CHANGE ORDER/C.O. No. 2

PROJECT: Calder Road Improvements Project  
CONTRACT No.: \_\_\_\_\_ PROJECT No.: ST1002

REFERENCE RFIs/RFPs: RFI 011

8" WATERLINE  
RELOCATION  
PLAN & PROFILE

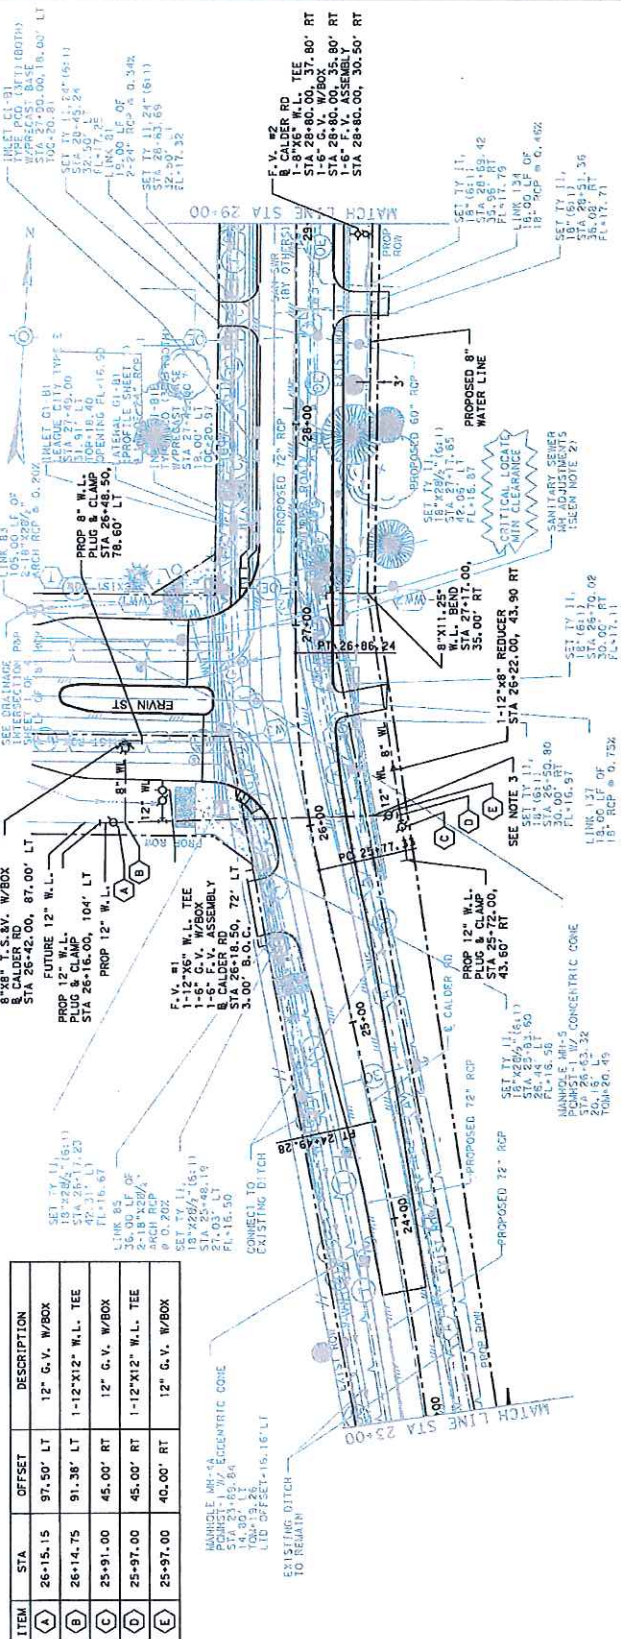
<u>CONTRACT AMOUNT</u>	<u>CHANGE TIME</u>
<b>ITEM 1 SCOPE:</b>	Relocate approximately 1,900 LF of 4-inch thru 12-inch water distribution line, and appurtenances, from Ervin Street to Big League Dreams.	\$234,661.00	30 Days
<b>JUSTIFICATION:</b>	<p>The City's contractor has performed field verification of the existing 8-inch / 6-inch <b>water distribution line</b> along the east side of Calder Road which is located in the existing roadside ditch. It appears that the water line only has <b>1' to 2' cover</b> in some places, between Ervin Street and Big League Dreams Parkway (1500 LF). The contractor says they need to <b>muck-out the existing ditch 2' to 3' to obtain a firm bottom</b> to start constructing the compacted embankment for the temporary asphalt detour lanes, and future concrete pavement subgrade. In doing so the <b>water line will conflict</b> with the excavation and embankment construction.</p> <p><b>In the original design</b>, it was anticipated that the Texas-New Mexico Power line would be relocated so as to be parallel with and no nearer than 3 feet inside Calder Road's new east right-of-way line. From a constructability and future maintenance standpoint, and in order to maintain clearance from the proposed power poles and overhead lines, the 8-inch water line, if relocated, would need to have a minimum of 4-foot clearance from the proposed poles and overhead power lines. That 4 foot clearance would <b>violate the TCEQ required 9-foot separation</b> between the sewer lines and water lines, thusly we determined to leave the 8-inch in place, under the future pavement, and protect it during construction.</p>

Subsequent to roadway design being complete, the proposed **location of TNMP's poles was revised** so that it would be approximately 6 feet off of the back of curb, instead of the 3 feet off of the right-of-way line. **This change made it possible to relocate the 8-inch water line** and comply with the TCEQ 9-foot horizontal clearance requirement between parallel public water lines and sewer lines.

In addition to the existing water line conflict, the design plans being prepared for **future Ervin Street and future Calder Road extension south**, includes a 12-inch water line extending south along Calder Road and west along Ervin Street. **Now is the time to construct the 12-inch water line** so the concrete pavement being constructed with the current Calder Road Project does not have to be removed and replaced for the future construction of the 12-inch water line crossing.
